TECHNICAL SERVICE BULLETIN RAFNA RAILGEAR

PUMP ASSEMBLIES FOR R-290 RAILGEAR PART NUMBERS R-048 AND R-048B

ISSUE DATE: January 25, 2008 TSB NUMBER: TSB-169 Rev A

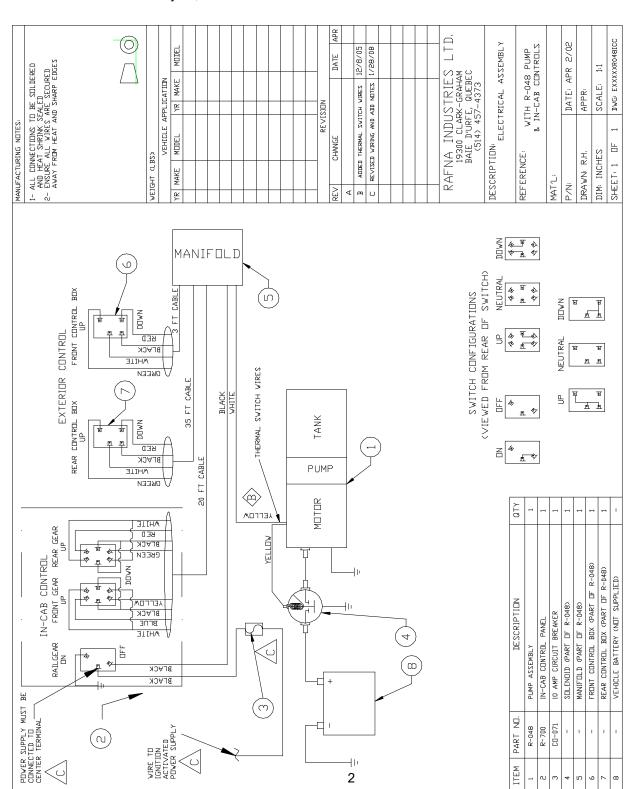
All further issues of R-048 and R-049B pump assemblies will now come with a thermal switch installed to protect the motor from over heating.

Make certain when replacing new pump assembly that the two, (2), additional thermal switch wires are attached as per Rev B drawings EXXXXXR048ICC and EXXXXXR048B. Added power supply to center terminal, and to wire to ignition activated power supply.

On replacement pump assemblies attach thermal switch wires per drawings EXXXXXR048ICC and EXXXXXR048B. Added power supply to center terminal, and to wire to ignition activated power supply.
